OHIO SCIENTIFIC, INC.

NEWSLETTER #24

December 14, 1979

CM-3 520 BOARD @ 2mhz

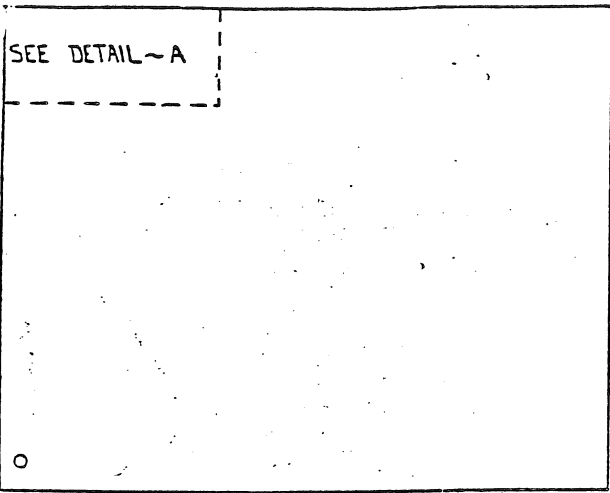
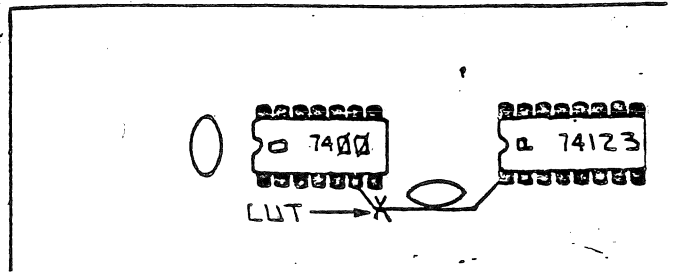
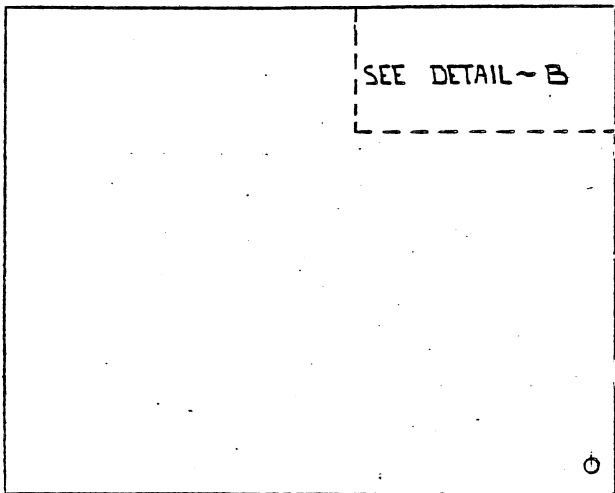
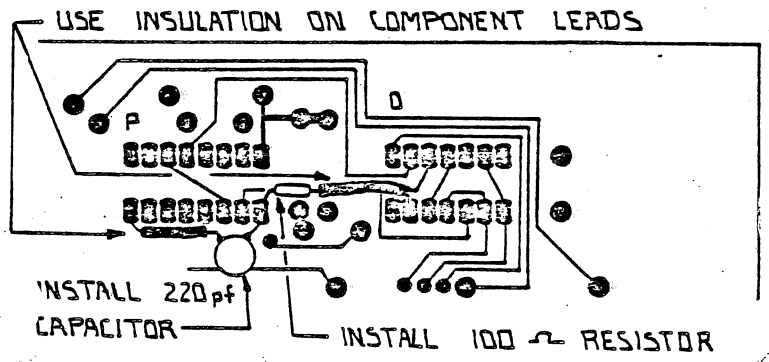
If one is encountering problems with a 520 board @ 2mhz, the change below should improve the boards reliability @ 2mhz. This modification is only required if one is encountering trouble.

ACTIVITY	LOCATION	VALUE
Cut Trace	C.S. IC-0,PIN 6 TO IC-P,PIN 1	-----
Add Resistor	N.C. IC-0,PIN 6 TO IC-P,PIN 1	100 ohm
Add Capacitor	N.C. IC-P,PIN 1 TO GROUND	220 pf

DIAGRAM 1

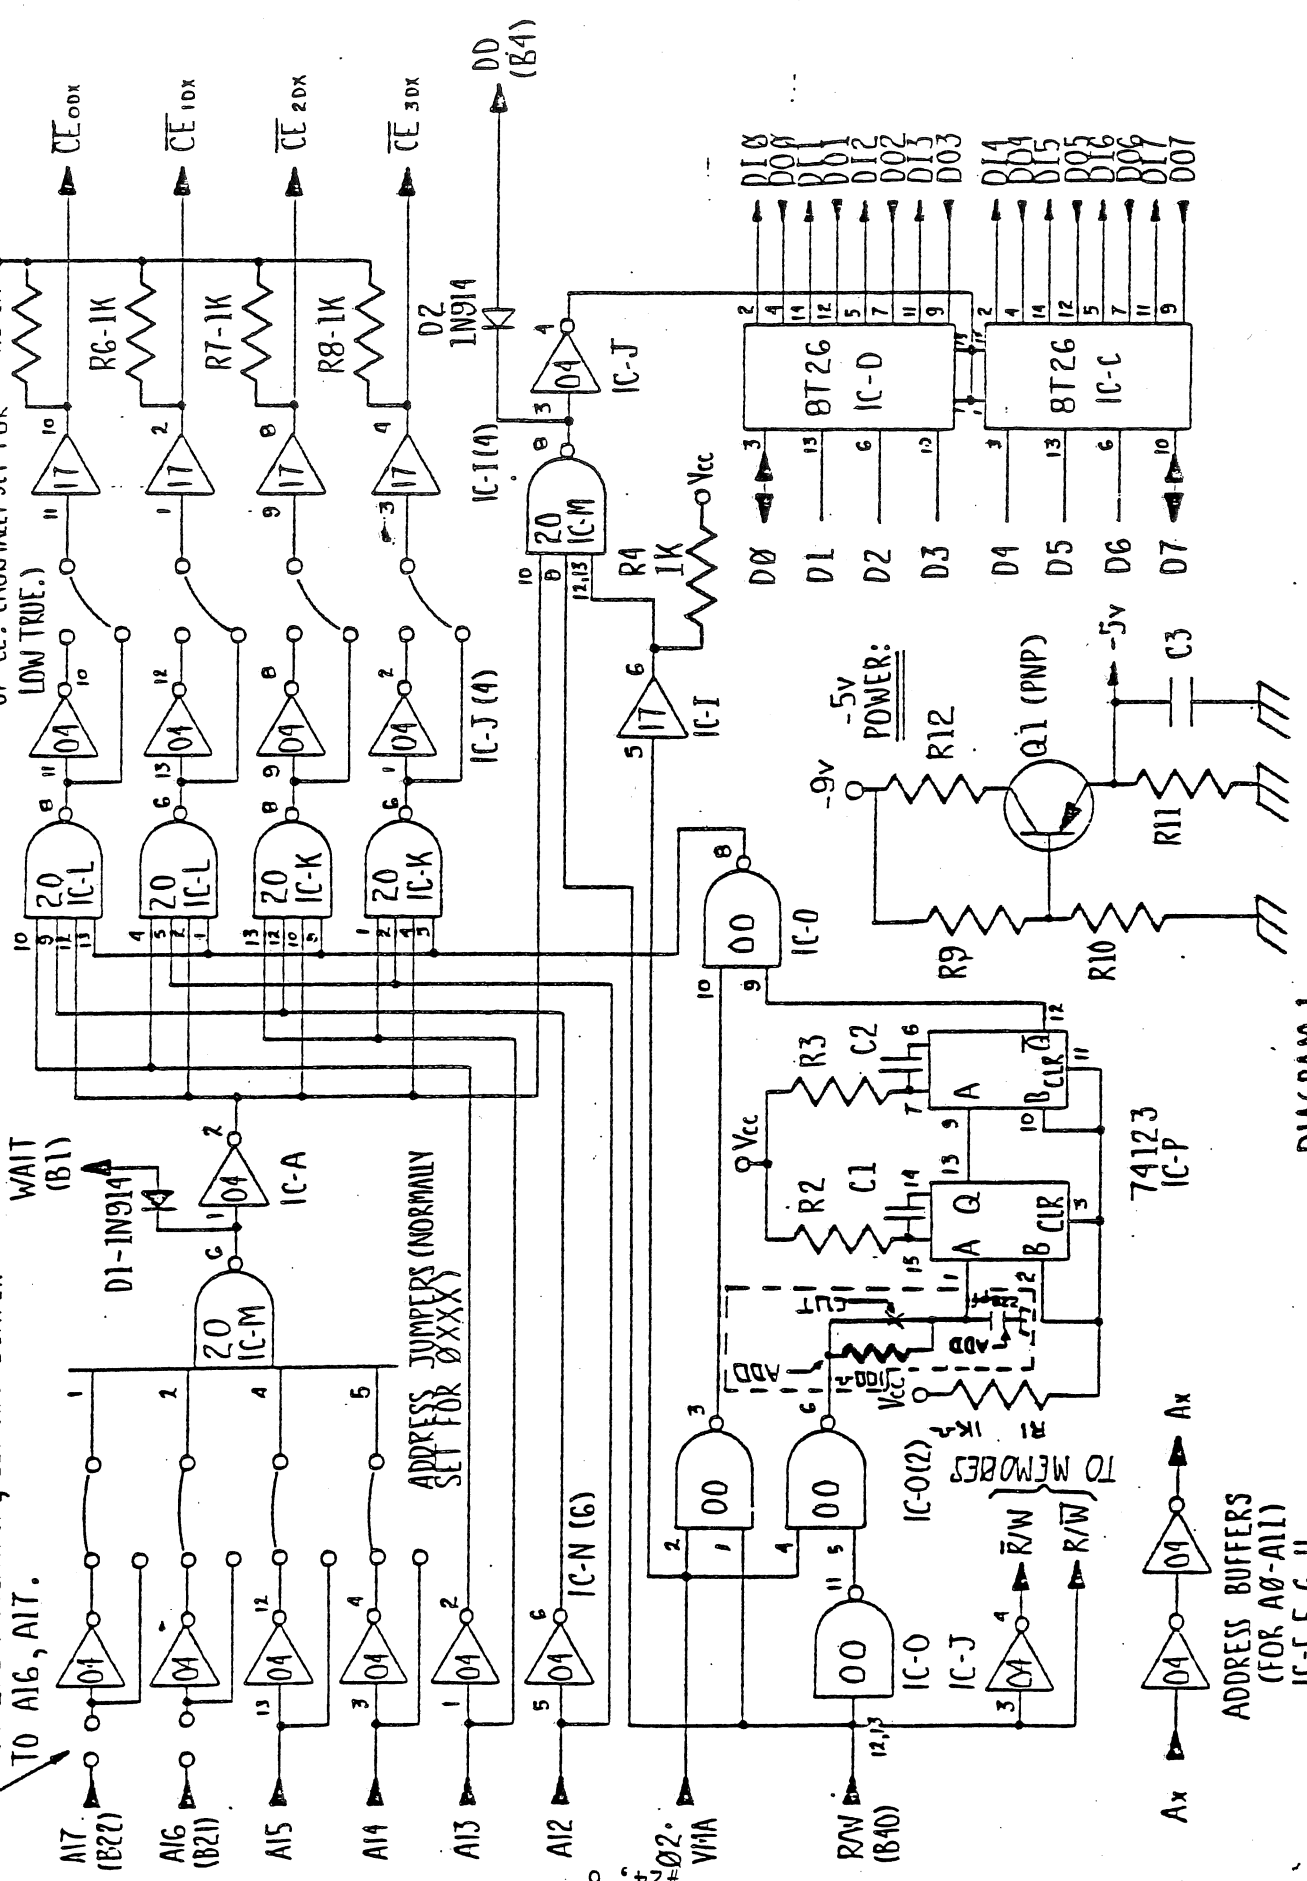
THESE TWO INPUTS ARE TIED TO GROUND.
FOR 256K OPERATION, CUT AND JUMPER
TO A16, A17.

JUMPER FOR CORRECT POLARITY
OF 'CE'. (NORMALLY SET FOR
LOW TRUE.)
